# Maules Creek Community Council

## Maules Creek Coal Mine Peer Review EIS Air Quality

Report No. 70Q-11-0312-TRP-511520-0-draft  
4 Oct 2011

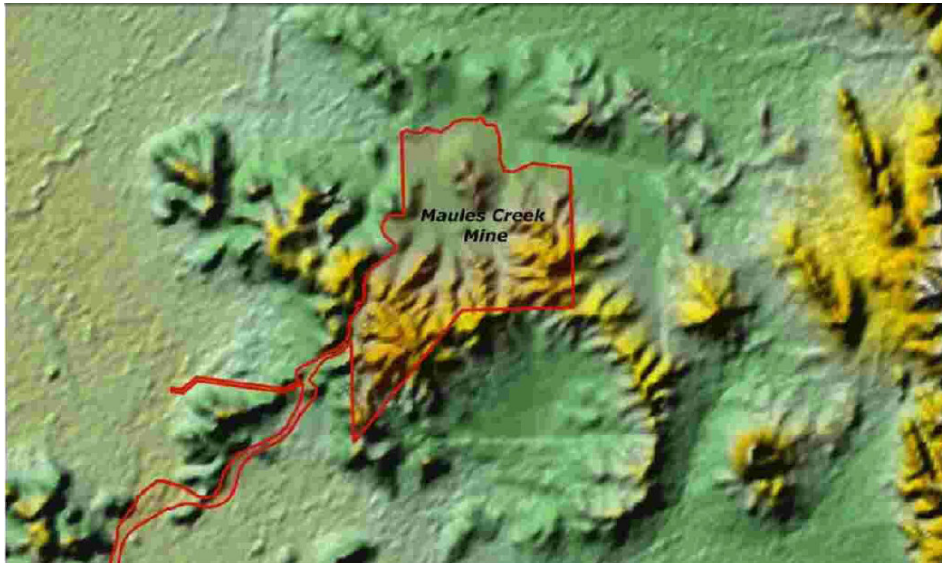
The use of a steady state Gaussian model in adverse terrain such as this is inappropriate. A Gaussian model does not properly account for flow steering. An assessment of the surrounding terrain has differential heights in immediate area of up to 100-150 m and further afield greater than 1000 m. Shown below is the terrain representation from the PAE Holmes report.

Adding to the complexity for the assessment that this brings is to the east of the site is a distinct feature that can be best described as “catchers mitt”. See attached image that shows this feature. While it is acknowledged that ISC-MOD is regularly used for the modelling of coal mines due to the in-pit modules are useful. However with the complexity of the surrounding terrain it is not suitable in this context alone.

The major limitation of the assessment is the use of a gaussian model in this context is totally unsuitable. Validation against a three-dimensional non steady state model such as CALPUFF is required.

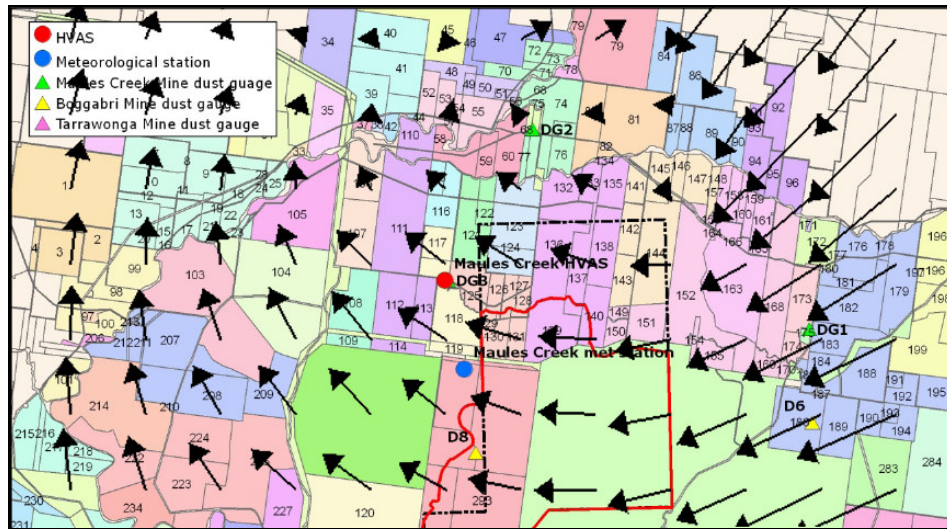
However visualisation of the wind fields show considerable spatial variability that would not be accounted for with a Gaussian model. An example hour of the windfields generated by VIPAC for the area are shown for a given hour area in the Figure below.

This data clearly shows how variable the winds are spatially. As shown in this example hour higher wind speeds would tend to carry dust off the mine site, however in other areas the wind speeds are low. In this situation dust would be carried off site and later encounter low winds speeds resulting in significant dustfall, which a Gaussian model cannot simulate.
